MS35206H
AMENDMENT 1
29 SEPTEMBER 1999

MILITARY STANDARD

SCREW, MACHINE-PAN HEAD, CROSS-RECESSED
CARBON STEEL, CADMIUM PLATED, UNC-2A

This amendment forms a part of MS35206H, dated 14 JUNE 1991, and is approved for use by all Departments and Agencies of the Department of Defense.

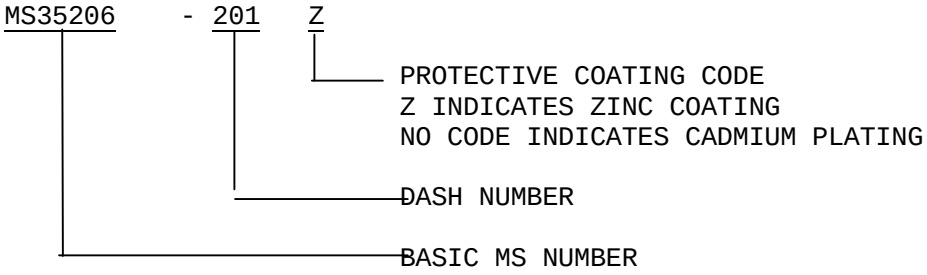
Under Part Number, add the option for Zinc Plating:

6. PART NUMBER: THE PART NUMBER SHALL CONSIST OF THE BASIC MS NUMBER FOLLOWED BY A DASH NUMBER FROM TABLE I, FOLLOWED BY A PROTECTIVE COATING CODE.

MS35206-201Z INDICATES – SCREW, MACHINE-PAN HEAD, CROSS-RECESSED ,CARBON STEEL, ZINC COATED, .086-56, UNC-2A, .125 LENGTH.
